#### ADDENDUM NO. 1, APRIL 14, 2009

RE: Ocean Avenue Elementary School City of Portland RFP No. 7109

A/E Comm. No. 3316.10

### **REVISED ELEVATIONS FOR SURVEY CONTROL POINTS:**

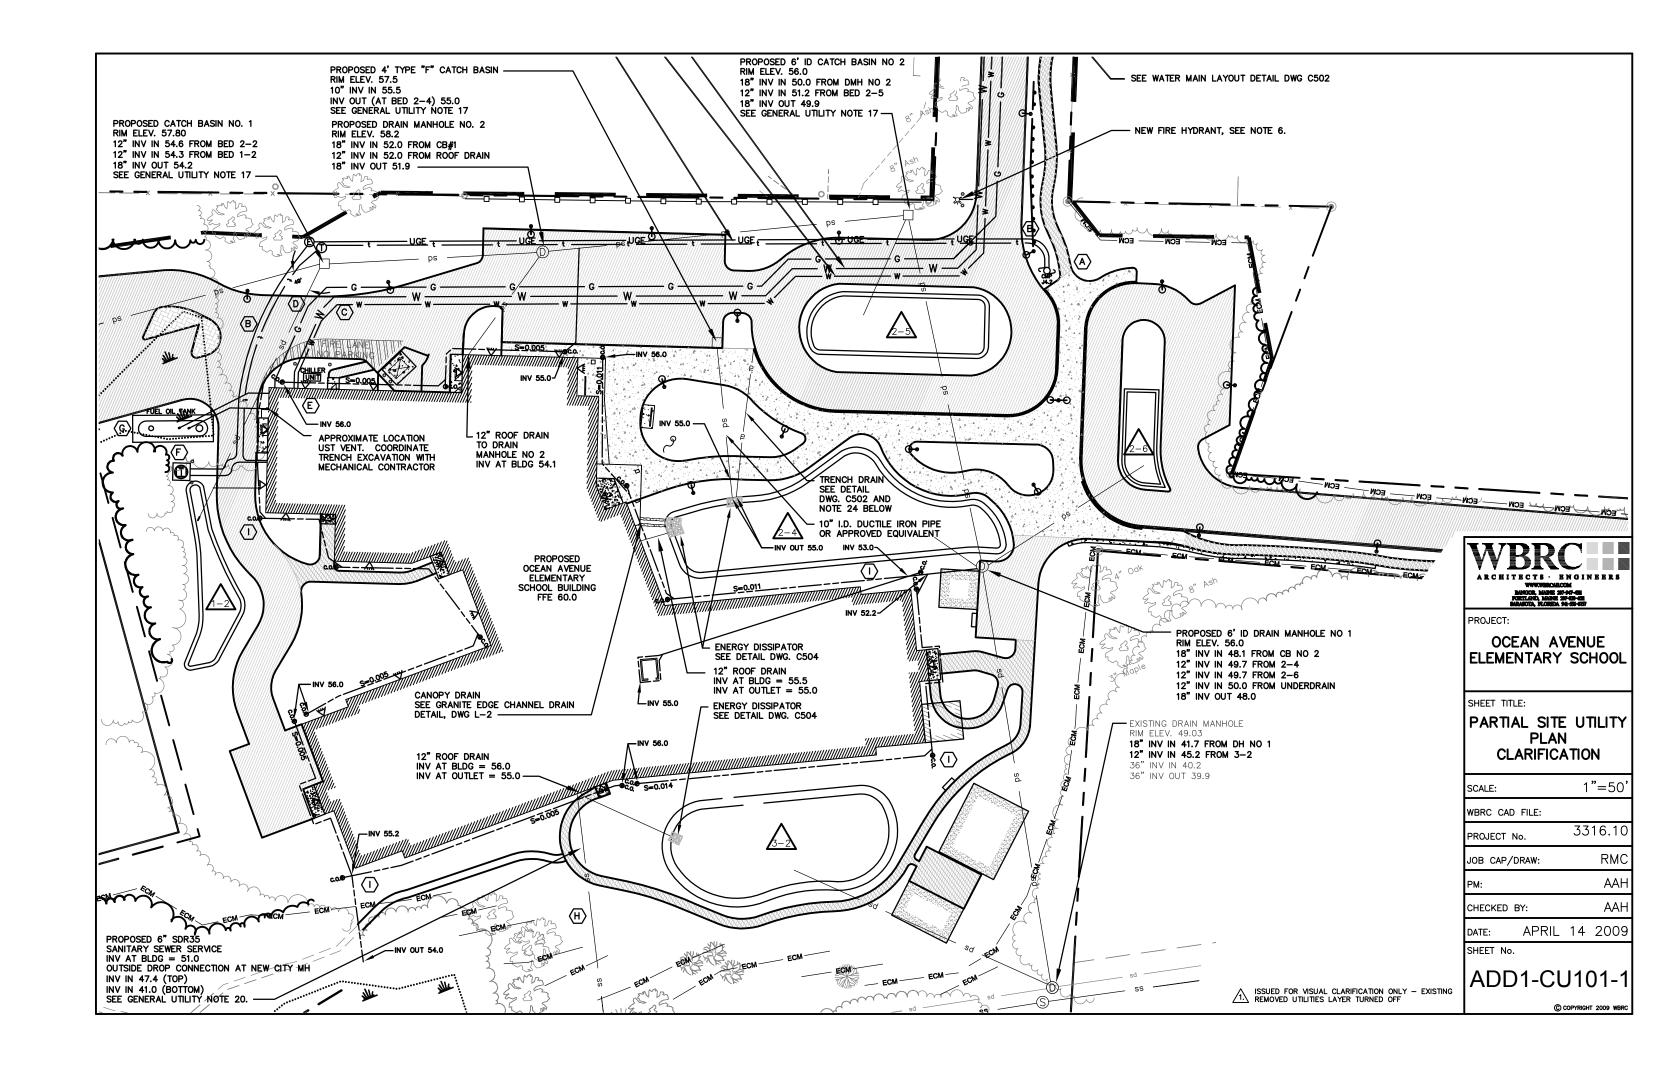
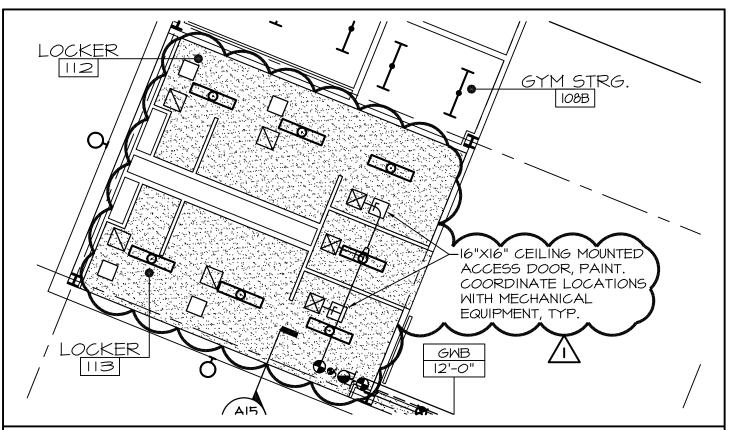
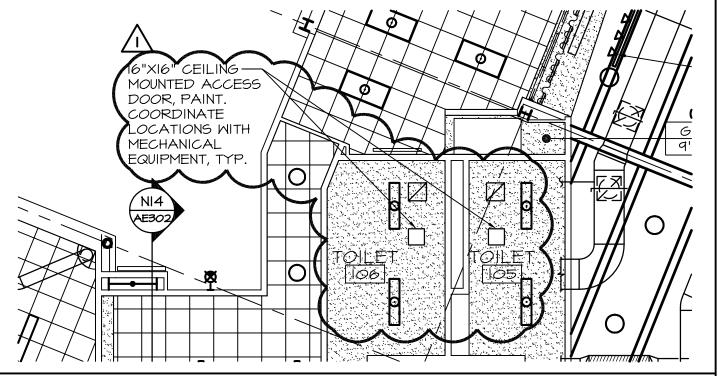
On April 6, 2009, Colonial Surveying Company performed an Elevation Check of the 2007 Survey Control shown on plans CS101 and CP101.

They observed some movement in the control points set in 2007 and have listed the correct elevations below. They also established a "Project Benchmark" on site. The Benchmark is a Railroad Spike set in the root of a large tree located on the east side of the Walton Street entrance and marks the southwest corner of land now or formerly of Joanne L. Gillies as shown on the Boundary Survey Plan, C-100. The elevation for the Project Benchmark is 57.42.

GMON W/DH 47.93 (UNCHANGED)
STA 25 49.65
STA 24 57.06
NEW PROJECT BENCHMARK 57.42

MEJ ADD1-AE103-A-1

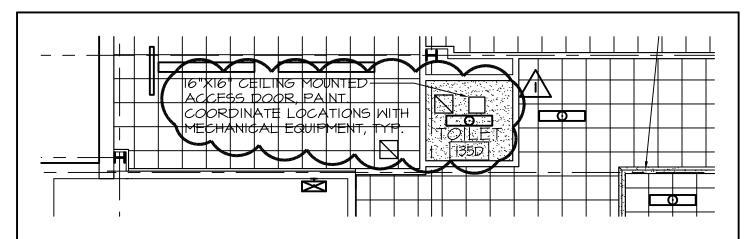
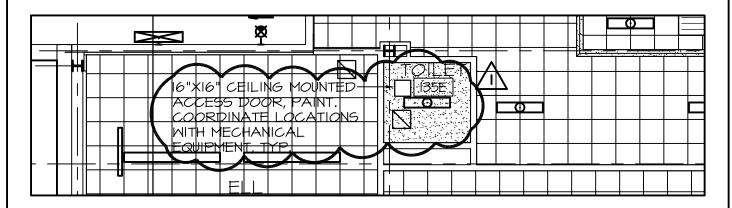
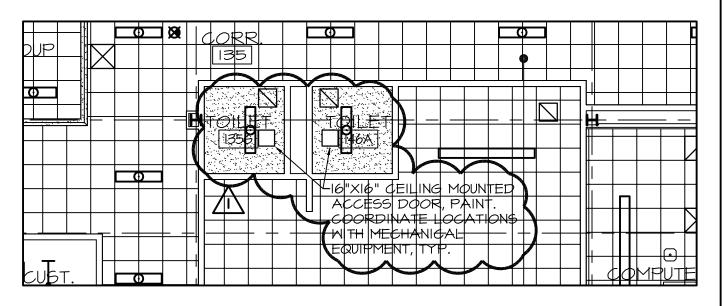
- 14. Sheet AE103-A, First Floor Reflected Ceiling Plan Seg. A, REVISE portions as indicated on Sketch ADD1-AE103-A-1.
- 15. Sheet AE103-B, First Floor Reflected Ceiling Plan Seg. B, REVISE portions as indicated on Sketch ADD1-AE103-B-1 & AE103-B-2.

SHEET TITLE:CEILING ACCESS DOORS ADDED

MEJ ADD1-AE103-C-1

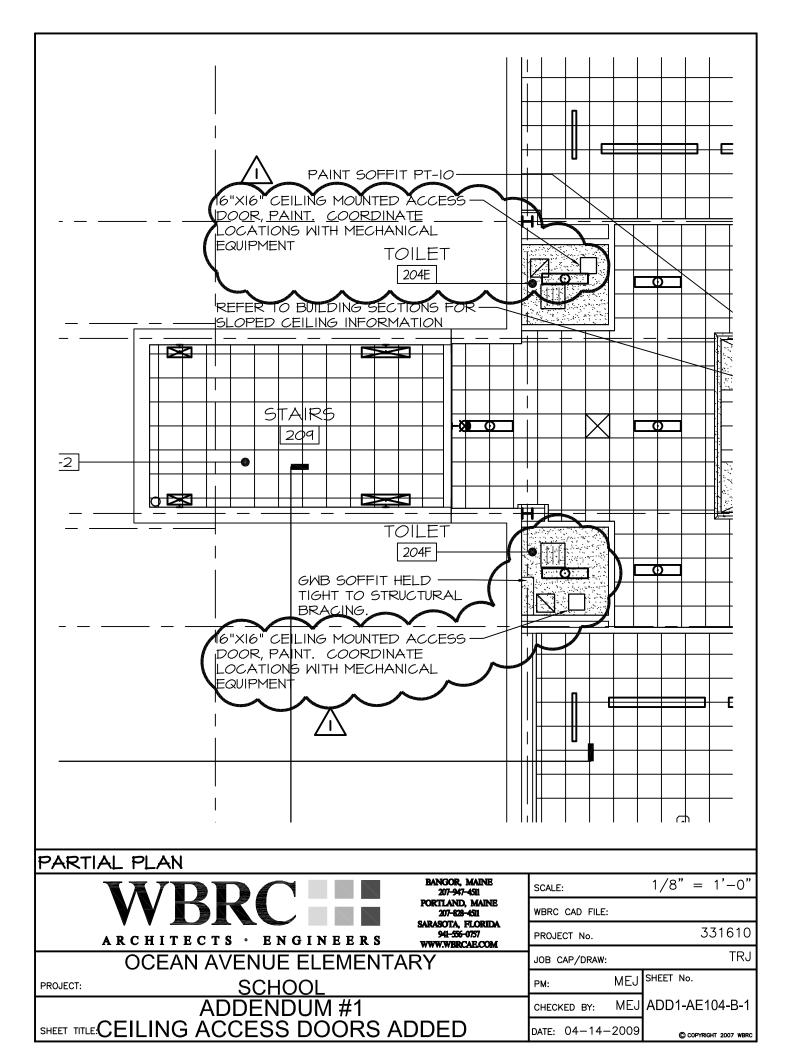
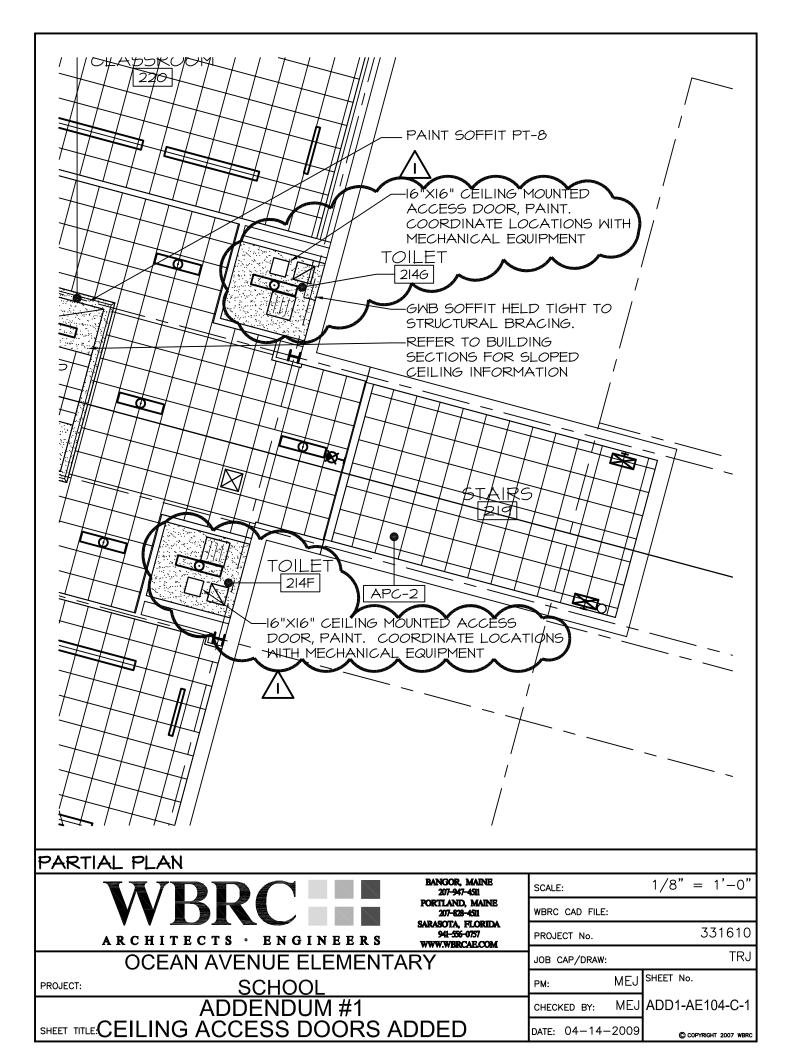
- 16. Sheet AE103-C, First Floor Reflected Ceiling Plan Seg. C, REVISE portions as indicated on Sketch ADD1-AE103-C-1.
- 17. Sheet AE104-B, Second Floor Reflected Ceiling Plan Seg. B, REVISE portions as indicated on Sketch ADD1-AE104-B-1.

ADDENDUM #1
SHEET TITLE:CEILING ACCESS DOORS ADDED

ADD1-AE201-1

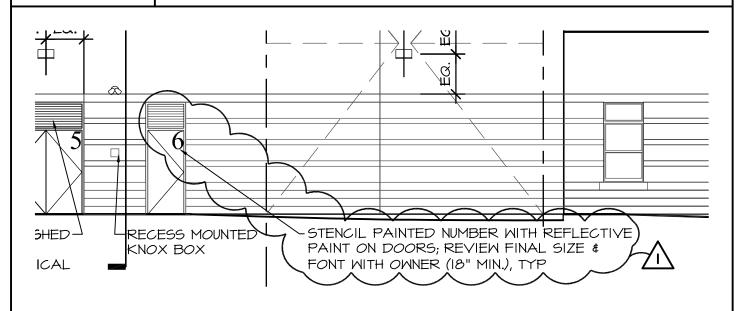
- 18. Sheet AE104-C, Second Floor Reflected Ceiling Plan Seg. C, REVISE portions as indicated on Sketch ADD1-AE104-C-1.
- 19. Sheet AE201, Exterior Elevations, REVISE portions as indicated on Sketch ADD1-AE201-1.

SCHOOL ADDENDUM #1 NOTE REVISION PM: MEJ SHEET No.

CHECKED BY: DMON ADD1-MP102-B-1

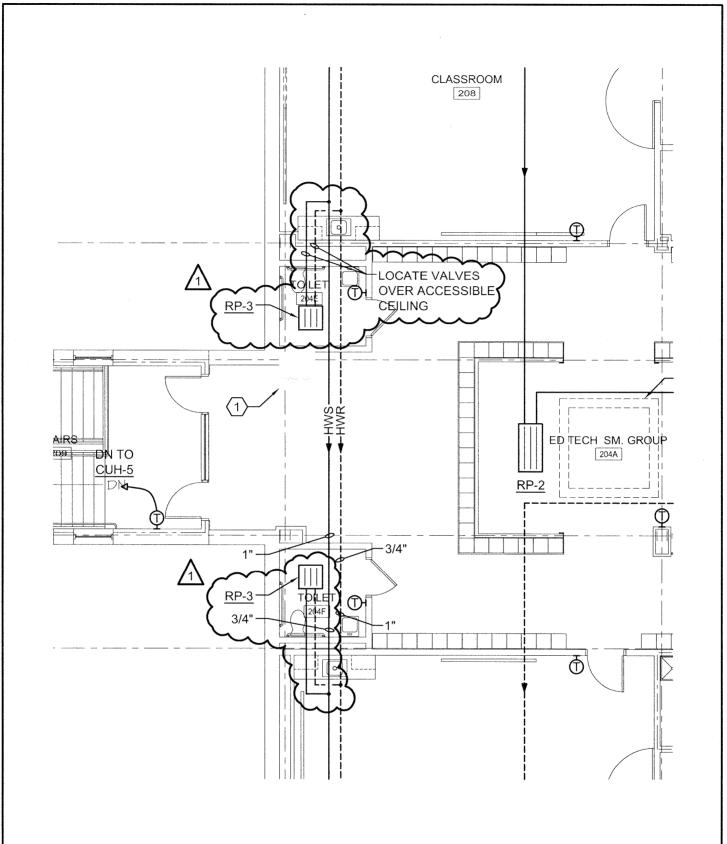
- 22. Sheet MP102-B, Second Floor Mechanical Piping Plan Seg. B, REVISE portions as indicated on Sketch ADD1-MP102-B-1.
- 23. Sheet MP102-C, Second Floor Mechanical Piping Plan Seg. C, REVISE portions as indicated on Sketch ADD1-MP102-C-1.

RADIANT PANEL PIPING
